Response to Request for Information – SSD 49295711 MOD 7 Harbourside Shopping Centre Redevelopment – Substation Plant

This letter has been prepared by Ethos Urban on behalf of Mirvac Retail Sub SPV Pty Ltd (Mircac) in response to the Request for Information received from the Department of Planning, Housing, and Infrastructure (DPHI) on 23 October 2025.

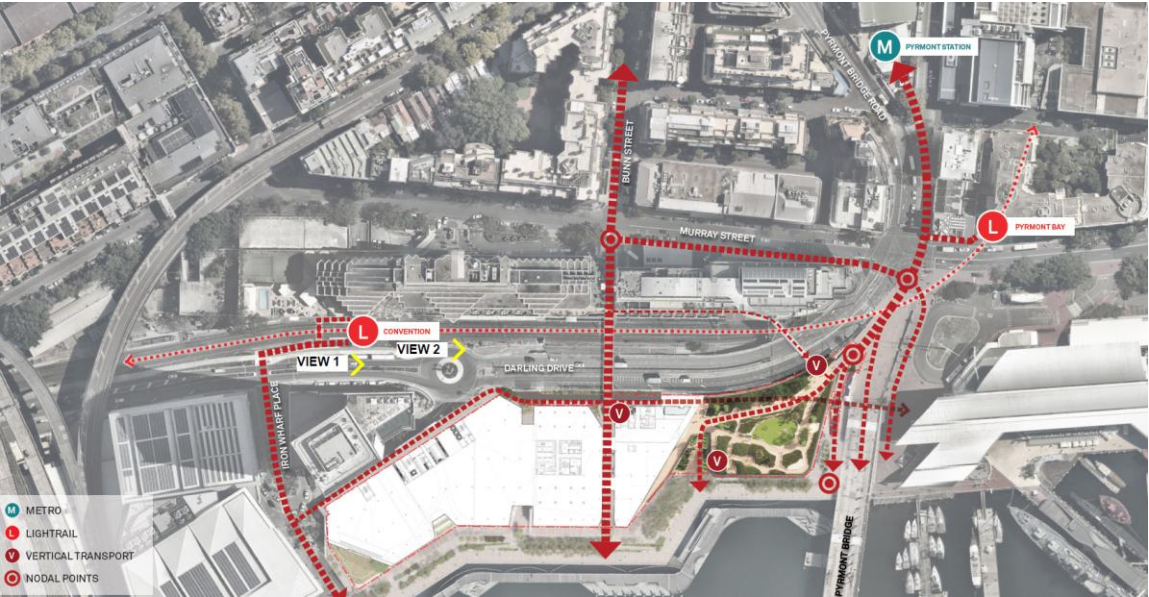
Amend the design of the fire hoods to enable pedestrian movements along both the west and east Darling Drive slip lane, noting the proposed hood walls would impede the public footpath and would require pedestrians to enter the road. The proposed design also creates concealment opportunities between Substation 2 and Substation 3's hood walls.

The area adjacent to substations 2 and 3 is not intended for pedestrian use, as there are no desire lines or pedestrian infrastructure that would direct pedestrians into this area. The area is intended as a back-of-house servicing laneway, with access generally only required for maintenance and servicing personnel.

As shown below, for pedestrians coming from the north, the desire lines generally do not draw people south into the site, with pedestrians generally staying in the north connecting between Pyrmont Bridge/Waterfront Garden and the Waterfront Promenade. For those that do walk south, the footpath on the eastern side of the Darling Drive slip lane is wide and has been designed to accommodate pedestrian movement.

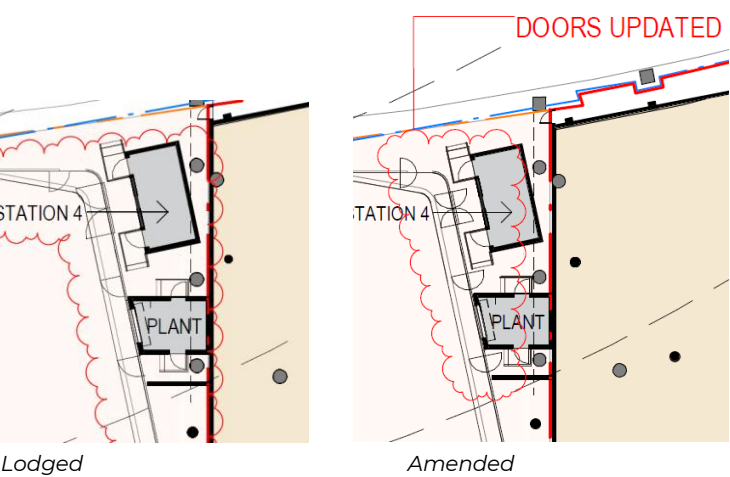
The proposed double swing doors to Substation 4 encroach into the roadway. It is suggested that doors opening into the roadway be limited/consolidated where possible. It is recommended a management strategy is developed for when doors are in operation.

Amend the design of Substation 4's access doors to not open onto the public road.	The design of Substation 4's access doors has been amended so that they do not open onto the slip lane. See below comparison of lodged (left) and amended (right) configuration. An updated Ground Level Plan is provided at Attachment A showing the amended configuration.
---	---

Indicative extent of slab roof shown in plan

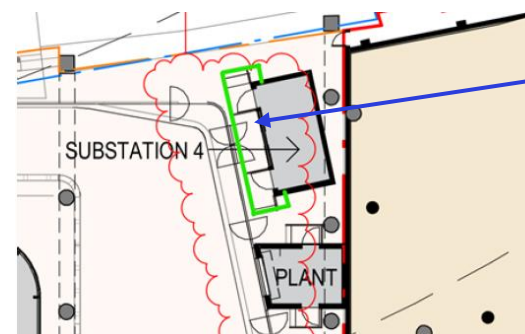
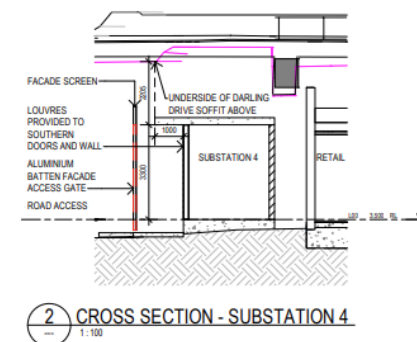
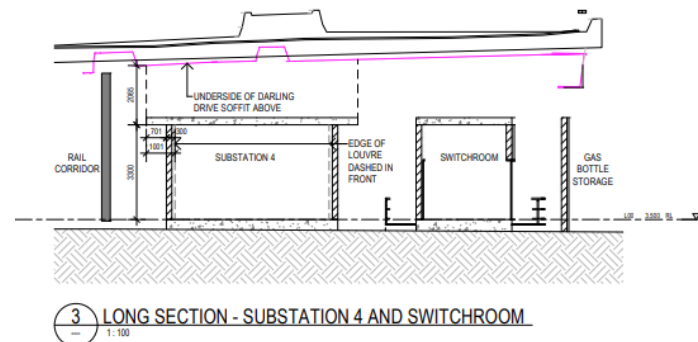
Clarification should be sought as to whether a fire protection hood is required for Substation 4 and where it will be located. There is concern that where required, the hood may overhang the access road.

As detailed in the Substation Servicing and Access Statement at **Attachment C**, the Substation 4 design incorporates the required fire protection within the substation structure, including an integrated slab awning. It therefore does not require the same external hoods as Substations 1-3. Refer below for indicative section drawings of substation 4.
